REV.	DATE	DCN #	DRAWING TREE #
A	FEB 17th 2006	E060057-00	E060059-A

SYSTEM ADVANCED LIGO

PART NAME
MAIN SECTION BUNG

SIZE DWG. NO.
A D040325

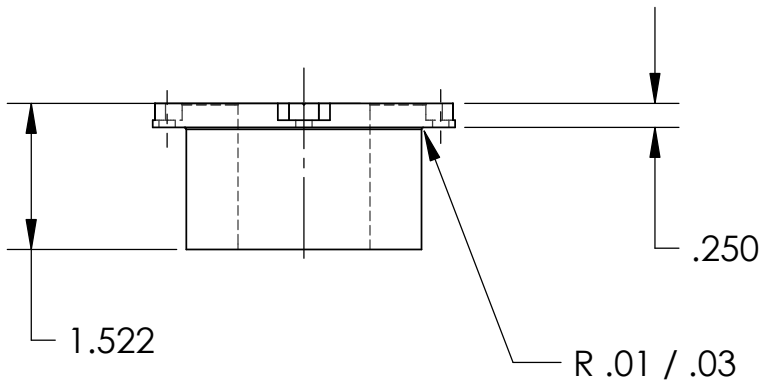
ADD VENT GROOVES
.02" WIDE BY .02" DEEP
